ATTACHMENT J
48-INCH LOW FLOW PIPE REVIEW

Re: September 2008 Flood Investigation
48-Inch Low Flow Pipe Review--Revised

Fawell Dam Spillway Rating Curve

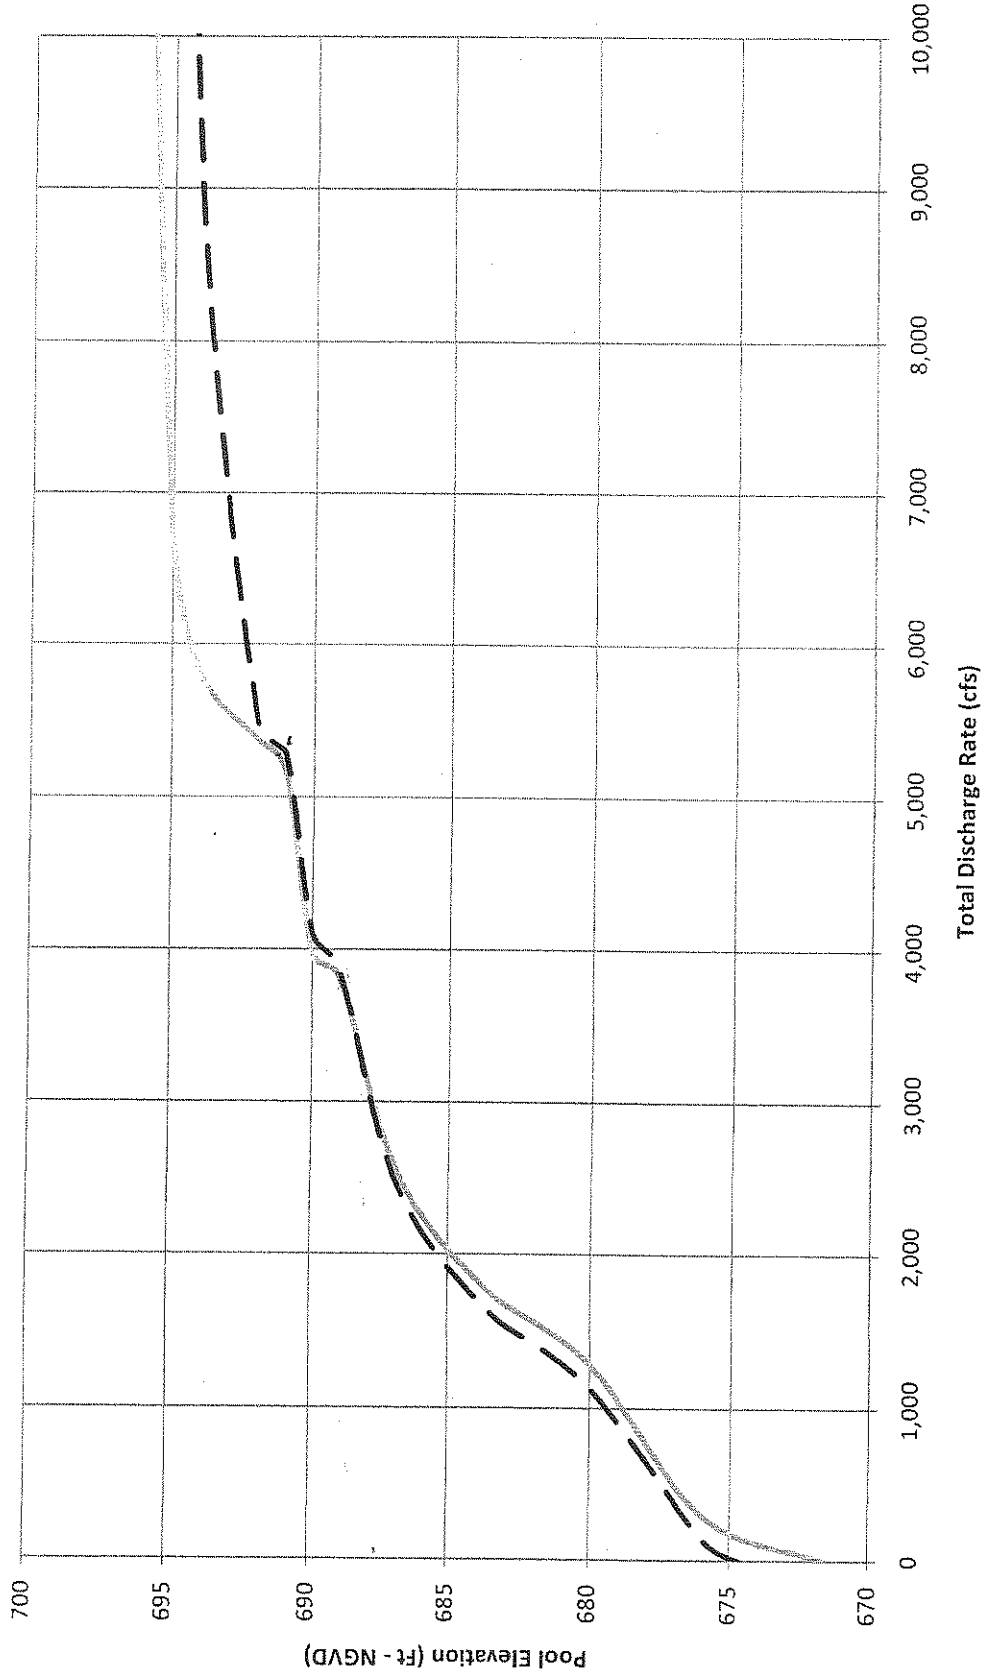
Grouting the 48-inch diameter low flow pipe reduced the flow capacity of the Fawell Dam spillway system. The October 1986 Illinois Department of Transportation-Division of Water Resources "*Strategic Planning Study For Flood Control, West Branch DuPage River, Fawell Dam*" presents the dam spillway rating table considering the low flow pipe functioning and the May 2001 URS Greiner Woodward Clyde "*Operation and Maintenance Plan, Fawell Dam and Saddle Dike*" presents the proposed spillway rating curve considering the 48-inch pipe being abandoned. The information presented in these documents are summarized in the attached figure showing the differences in the calculated flows through the dam spillway. Please note that the calculations used to develop the information presented in each of the reports have not been reviewed as part of our investigation.

Differences in the rating curves can be attributed to the 48-inch pipe being open vs. grouted, the emergency spillway being lowered to 693 feet, and that different methods were used to calculate the spillway flows. The analyzed/designed function of the dam in each of these reports appear to consider the appropriate spillway configuration which includes both the flood pool storage volume change and 48-inch pipe impacts. It appears the greatest differences in the spillway discharge rates due to the grouting of the 48-inch pipe are for the smaller flood events and there is less of an impact as the flood event increases.
